Cryogenic Equipment Sizing and Locations

Mike Zuckerbrot, Kathrine Cipriano, Min Jeong Kim

LN2 Phase Separator

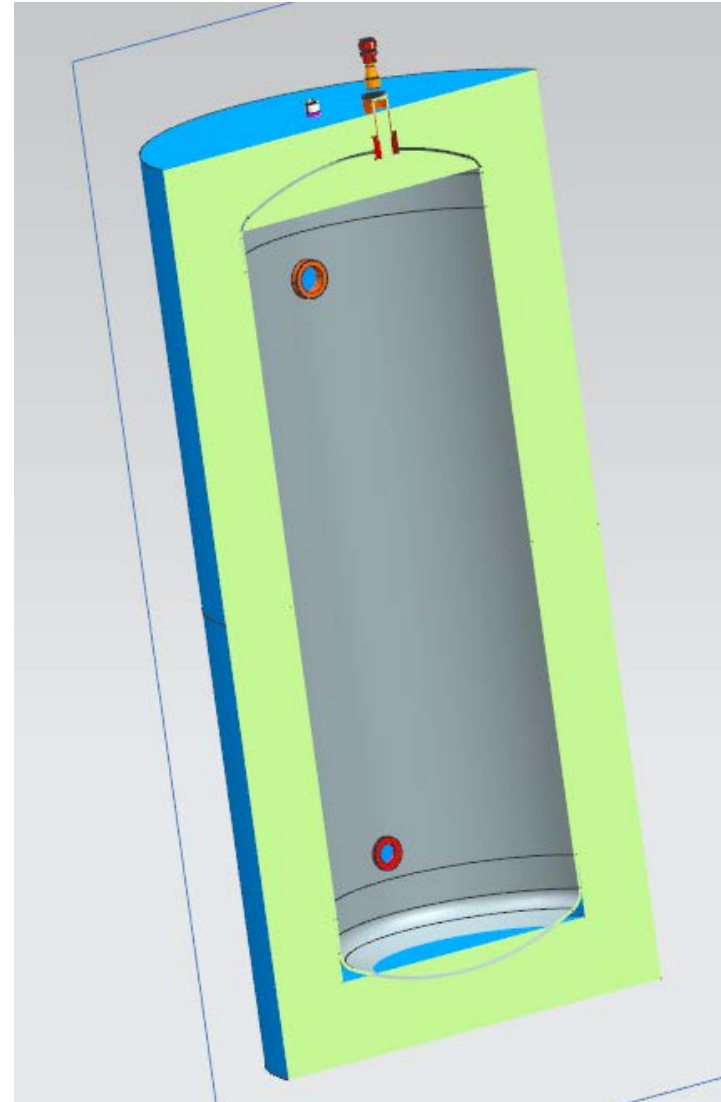
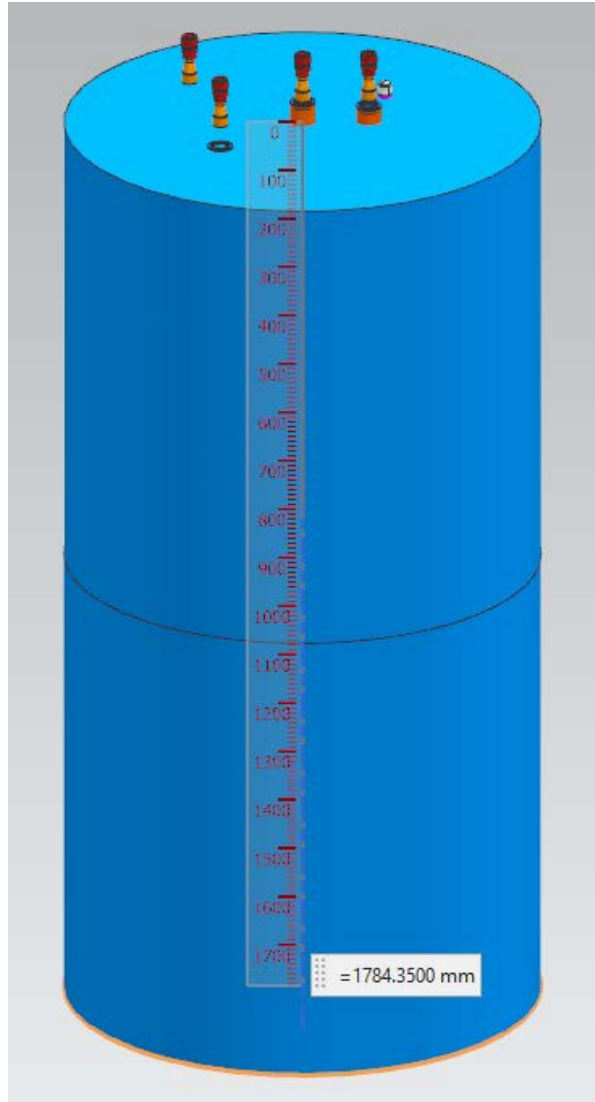
- Increase diameter to 48", increase height by ~1 foot.
- The height and diameter can be flexible, the total volume is what's important.
- The support structure in the model does not necessarily have to be duplicated if something else makes more sense.
- This needs to be located at an elevation higher than the cryostat, more specifically it must be above the condenser.

Condenser

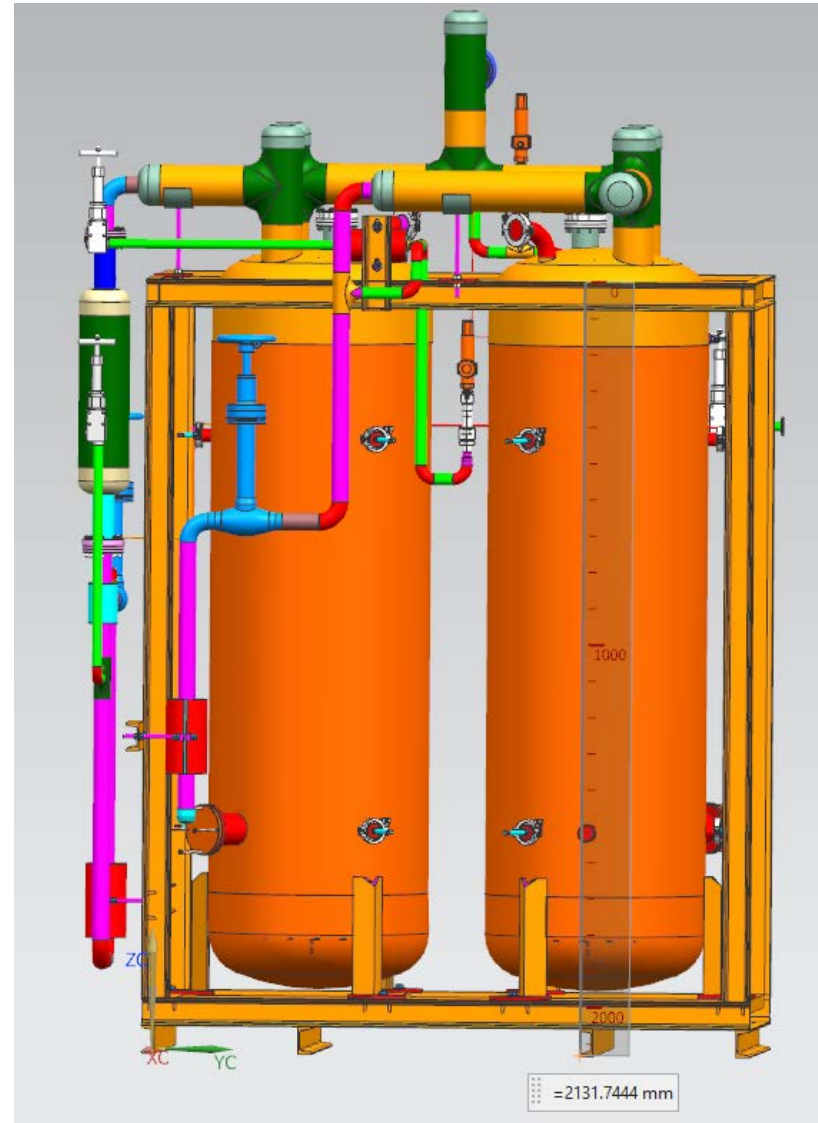
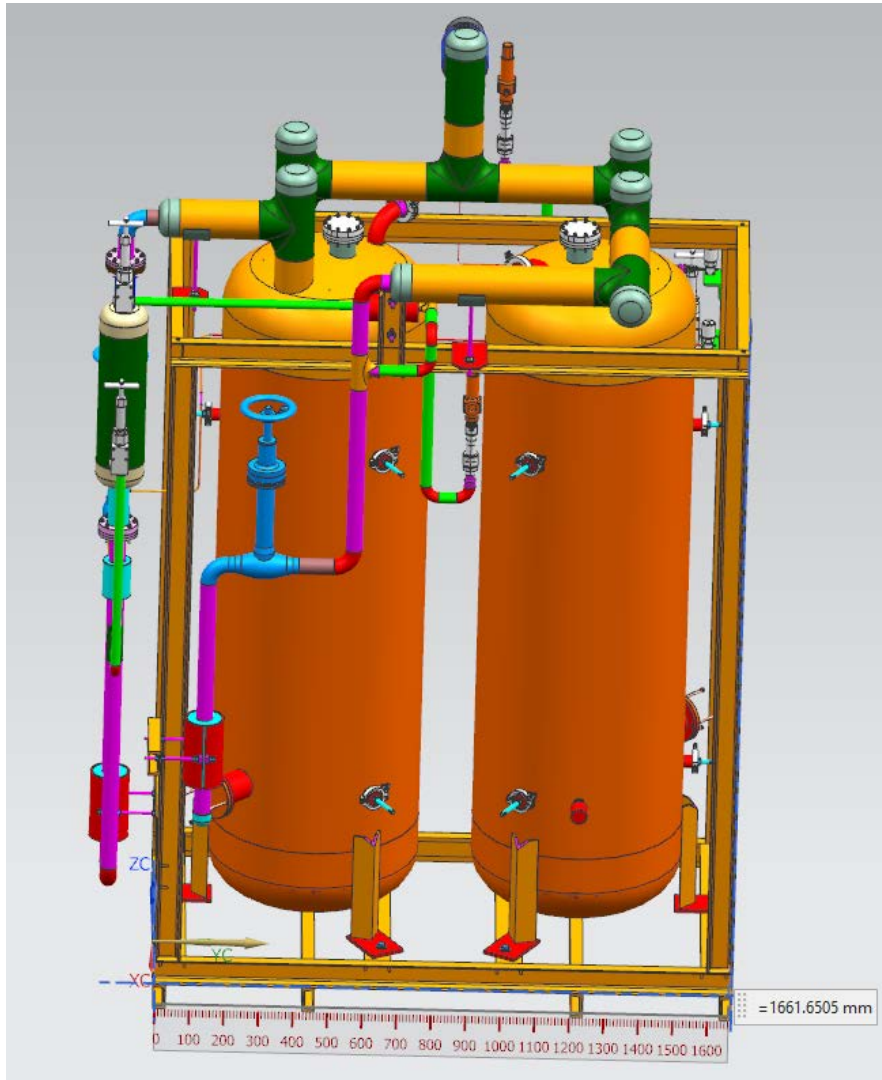
- Increase diameter to 48", increase height by ~ 1 foot.
- Again, dimensions can be flexible if volume is maintained.
- There is also the option to use multiple smaller vessels.
- Location needs to be above the cryostat, and under the phase separator

LAr Filter Skids

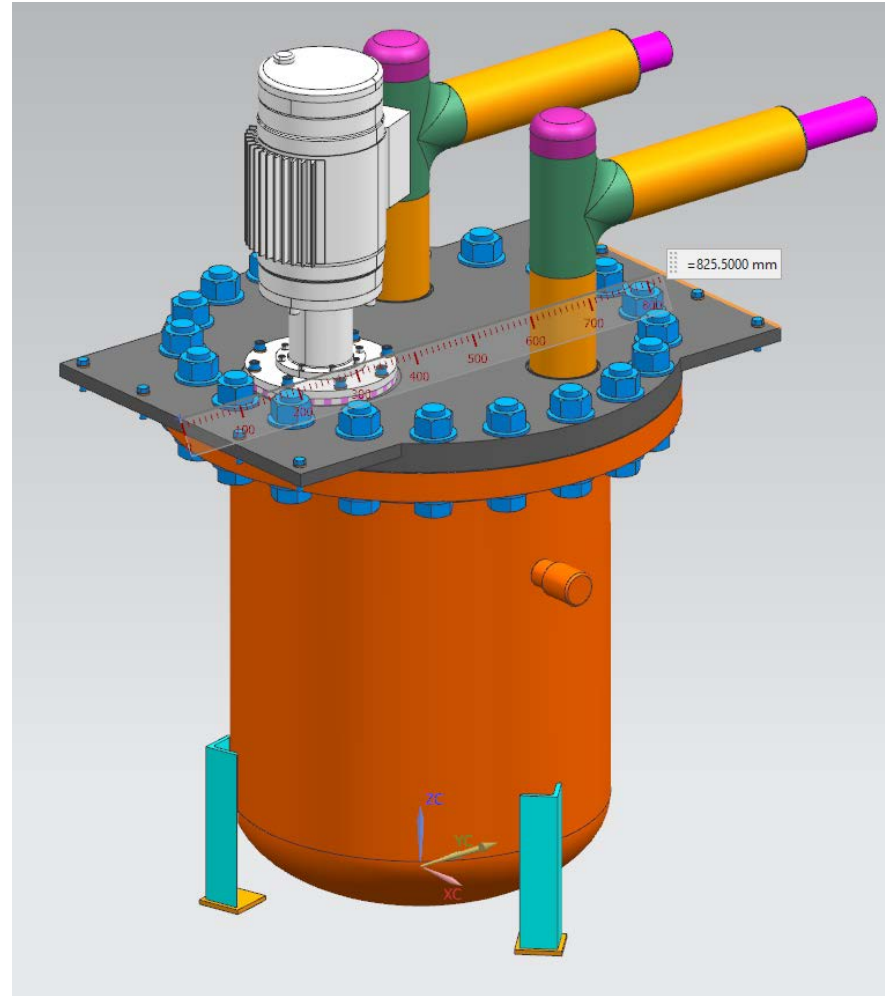
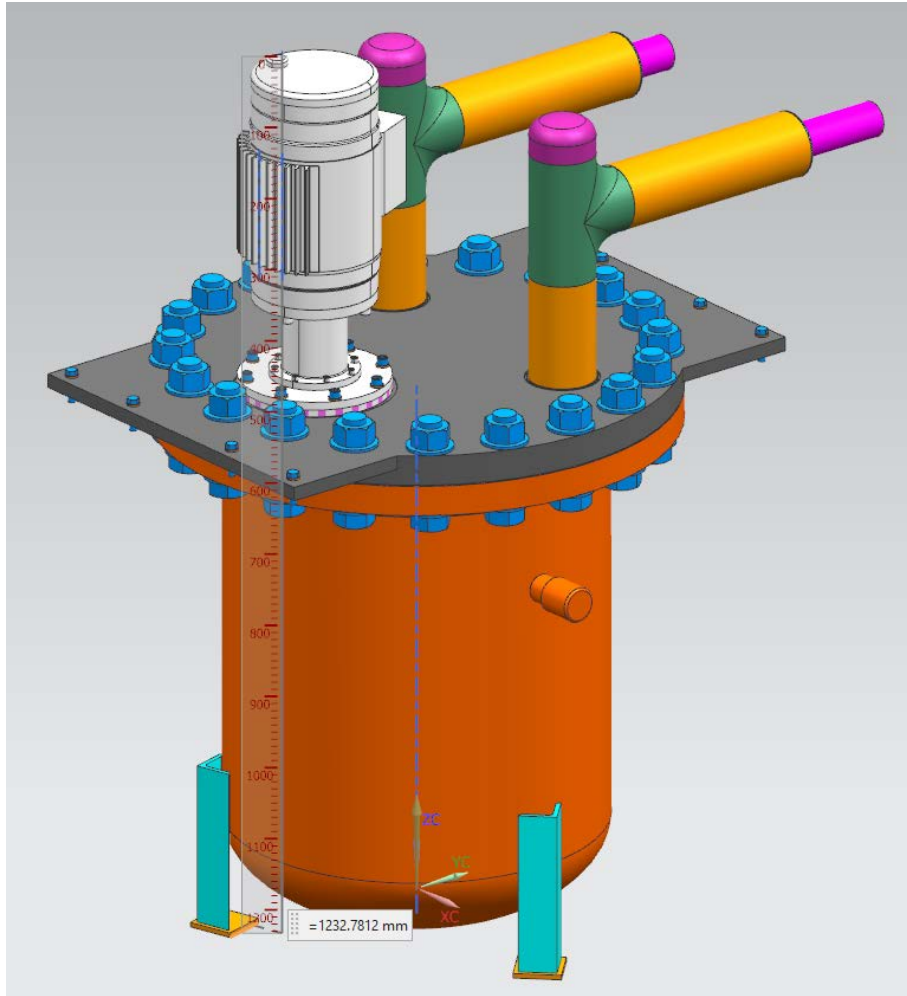
- Can remain the same.
- Location is not critical.
- Two of these skids for redundancy.
